Docket No. 50-305

Kewaunee Nuclear Power Plant

EXEMPTION

SAFETY EVALUATION BY THE OFFICE OF NUCLEAR REACTOR REGULATION
SUPPORTING A SPECIFIC EXEMPTION TO 10 CFR PART 50 §48(c)(4)
RELATED TO THE APPENDIX R ALTERNATE SHUTDOWN SCHEDULE FOR
KEWAUNEE NUCLEAR POWER PLANT
DOCKET NO. 50-305

Figure 1

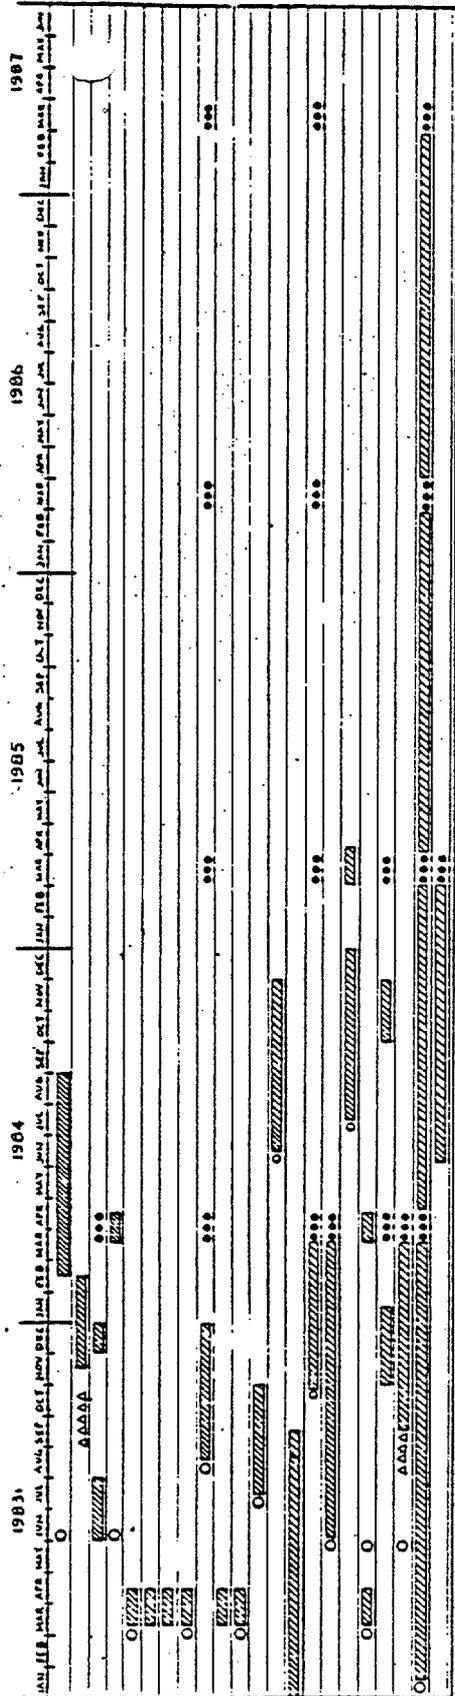
This is an update on construction activities completed to date and what is planned for the remaining months in 1983 and 1984. Also, the project schedule for 1984 through 1987 is updated (see figure 1).

Figure 2

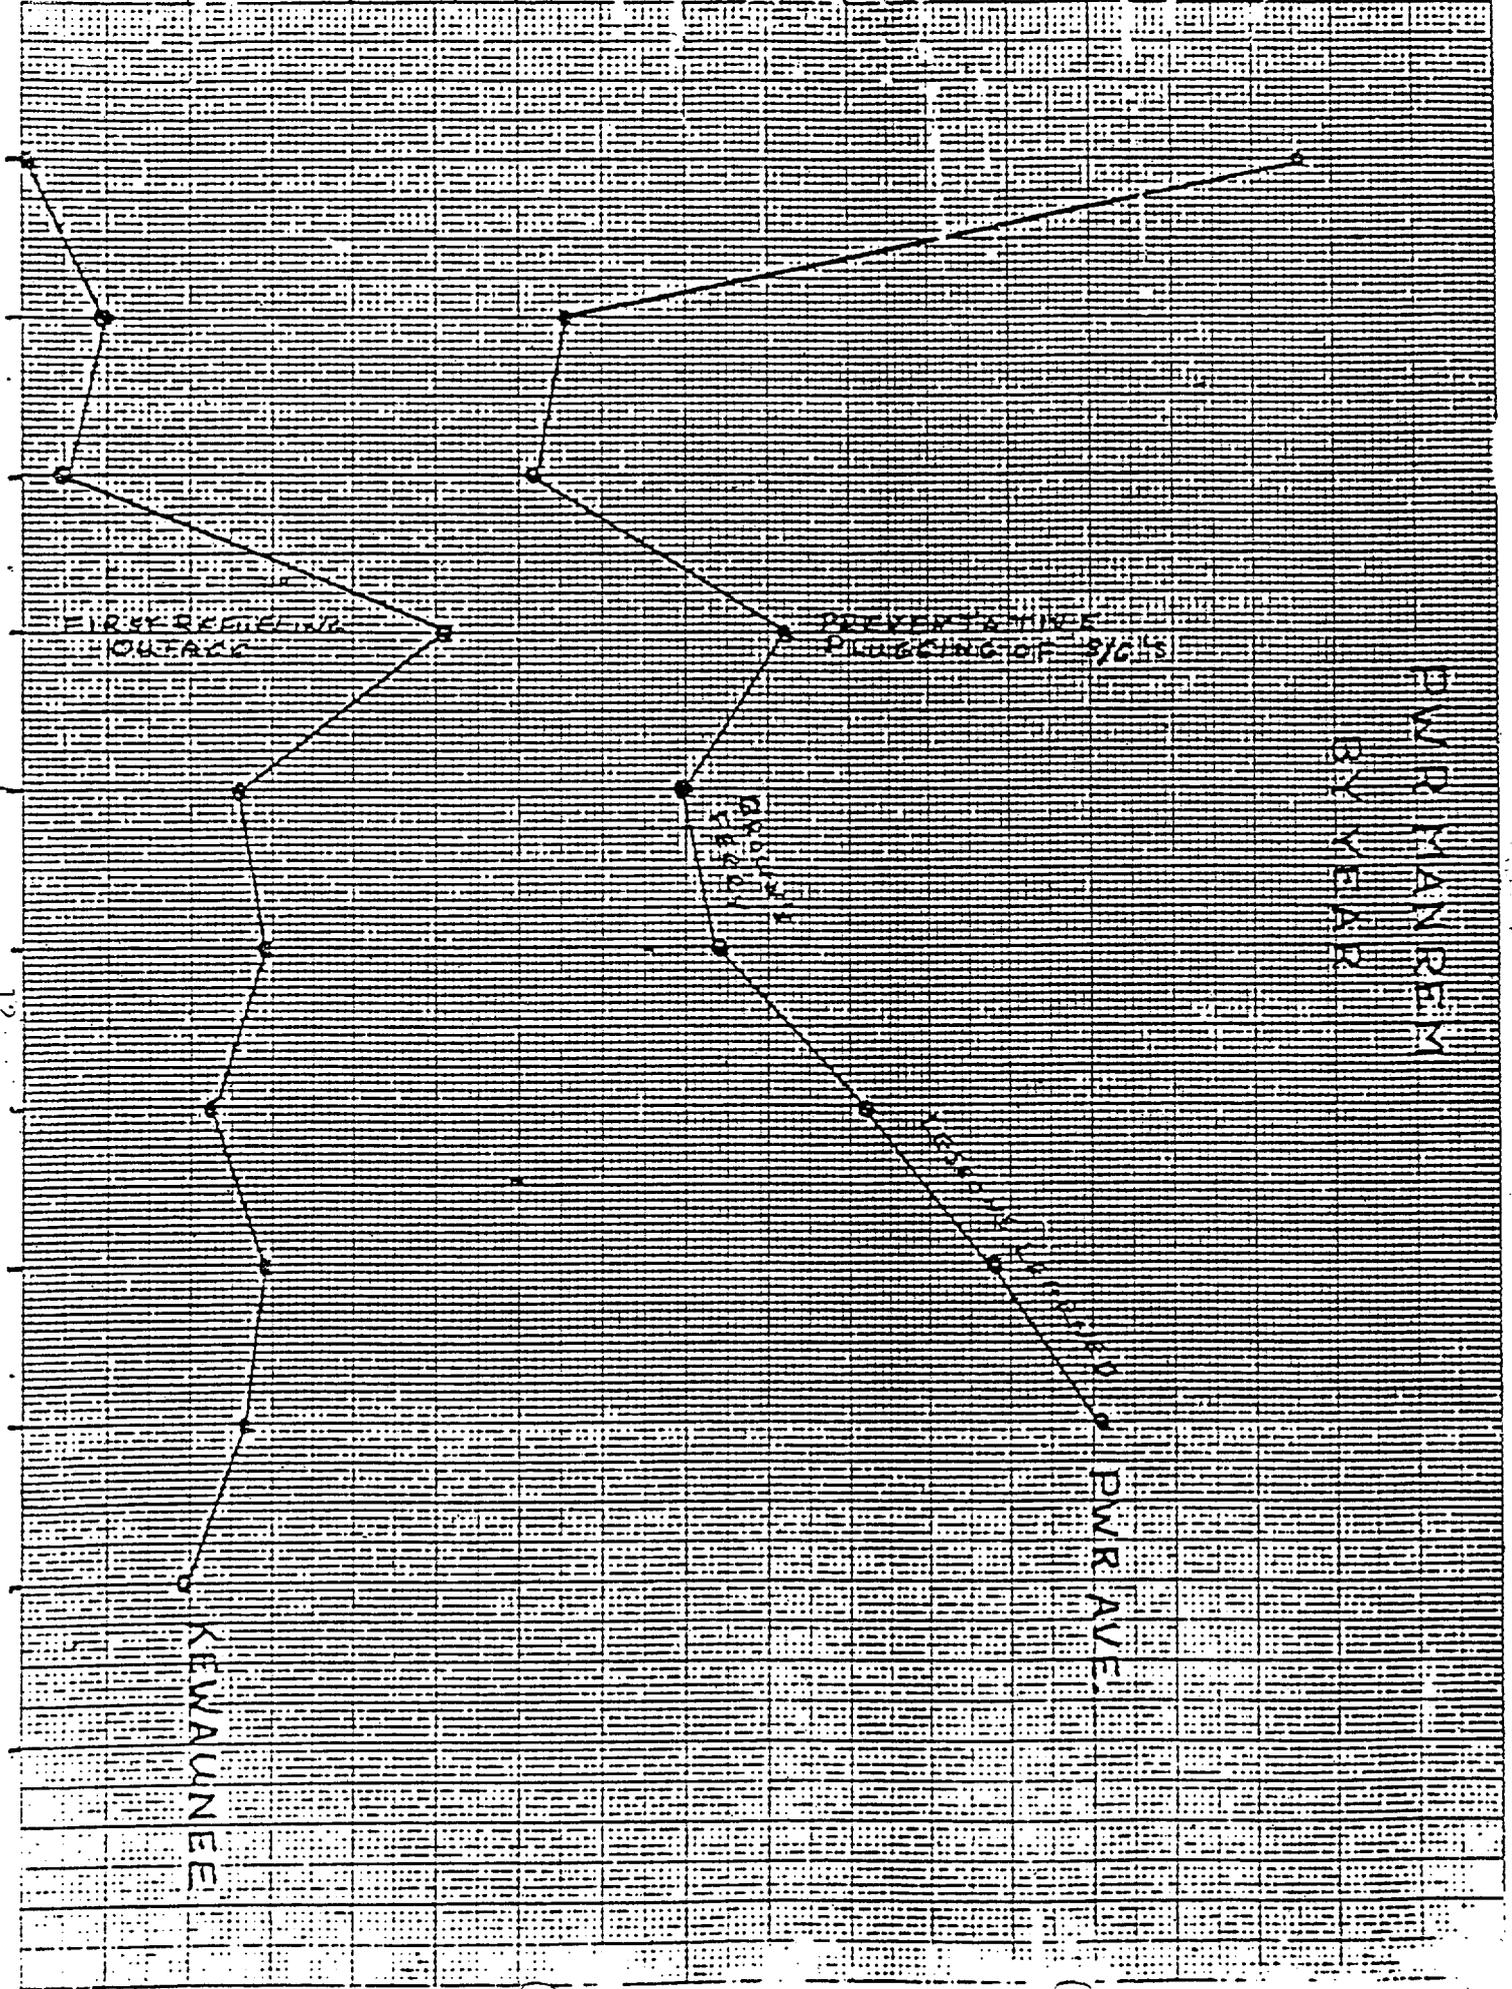
The facility's low annual exposure is shown in relationship to the rest of the operating PWRs in Figure 2. The increase in PWR average annual man-rem exposure between 1975 and 1981 can be attributed in part to the effects of preventative plugging of steam generators in 1976, the Browns Ferry modifications (BTP 9.5-1) in 1977 and 1978, and TMI Lessons Learned through 1981, as indicated in latest industry data available from NUREG-0713. The man-rem exposure at the facility through this period was essentially stable or declining even though this facility was timely in installing TMI fixes. The reason for this is the philosophy of utilizing smaller and stable work crews on a year-round basis. The longer a person is at a specific plant, the more efficient he becomes in accomplishing his tasks with minimum exposure.
